# ADDENDUM NO. 1

**April 29, 2022**

**NEW ADMINISTRATION CENTER, ALTERNATE EDUCATION AND  
RESOURCE CENTER AND RELATED WORK PROJECT  
Crown Point, IN 46307**

This Addendum forms a part of and modifies the Bidding Requirements, Contract Forms, Contract Conditions, the Specifications, and the Drawings dated April 15, 2022 by Gibraltar Design. Acknowledge receipt of the Addendum in the space provided on the Bid Form. Failure to do so may subject the Bidder to disqualification.

NTS

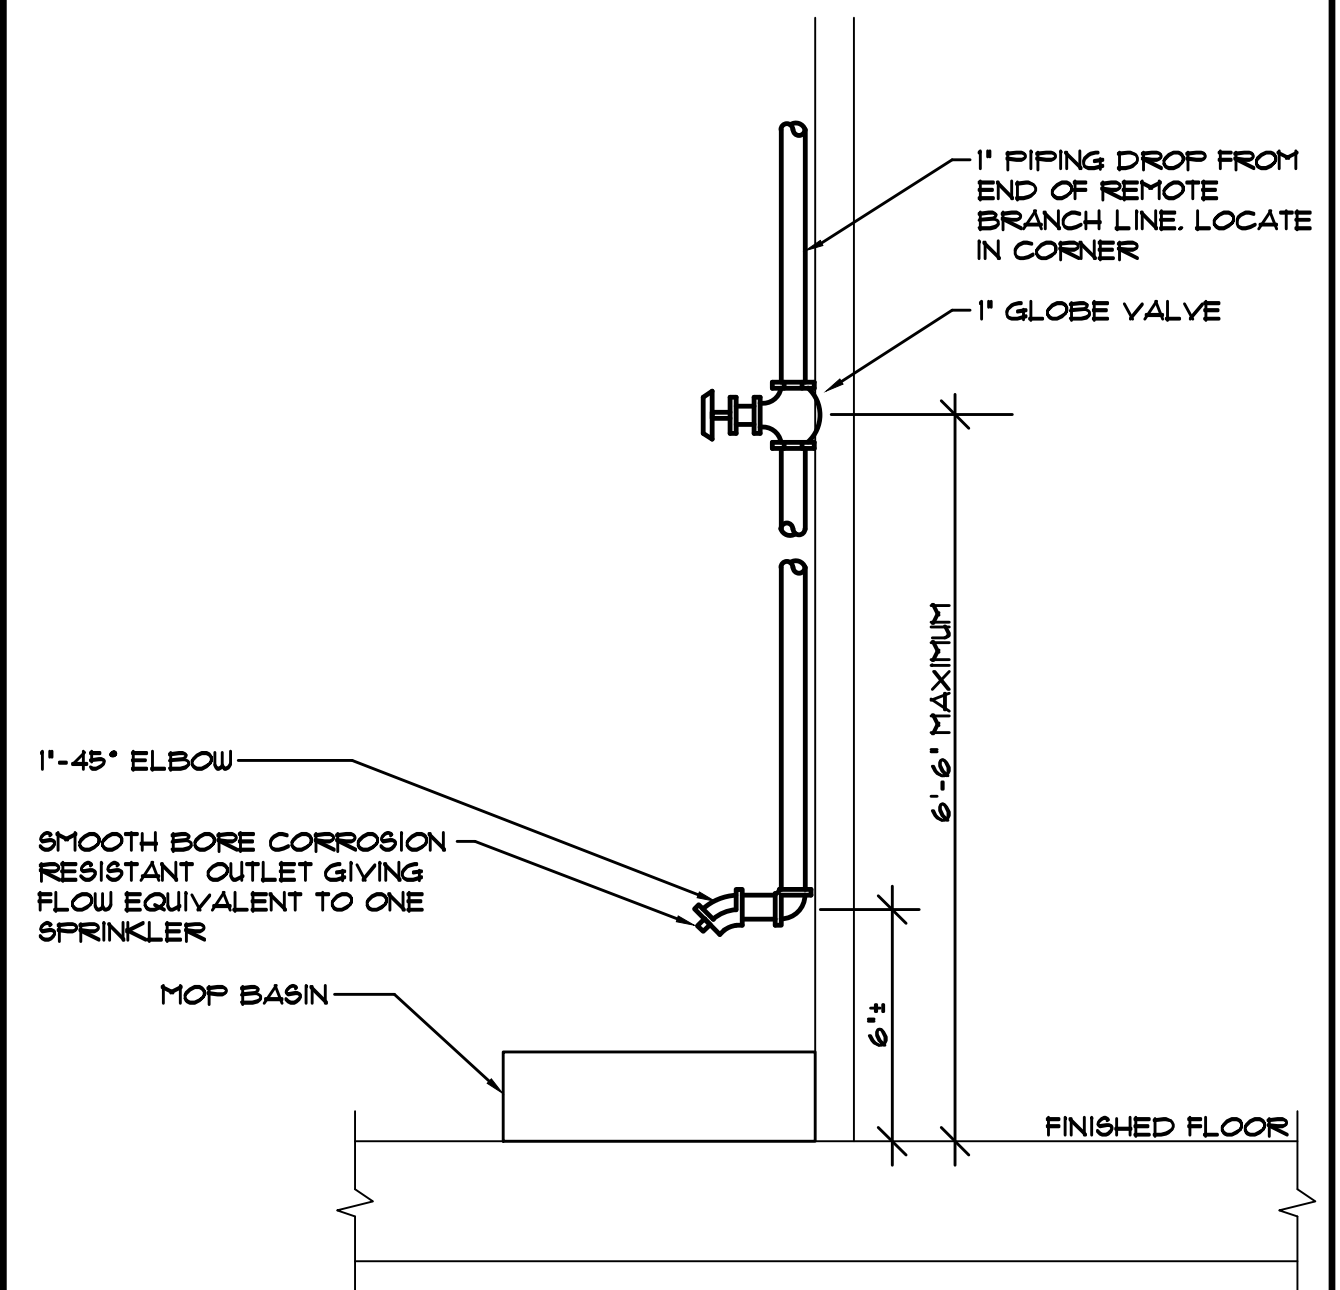
**11. Sheet FP-001**

- A. Refer to revised, full size drawing, included in this Addendum, for addition of "Enlarged Data Head End Plan – Fire Protection".
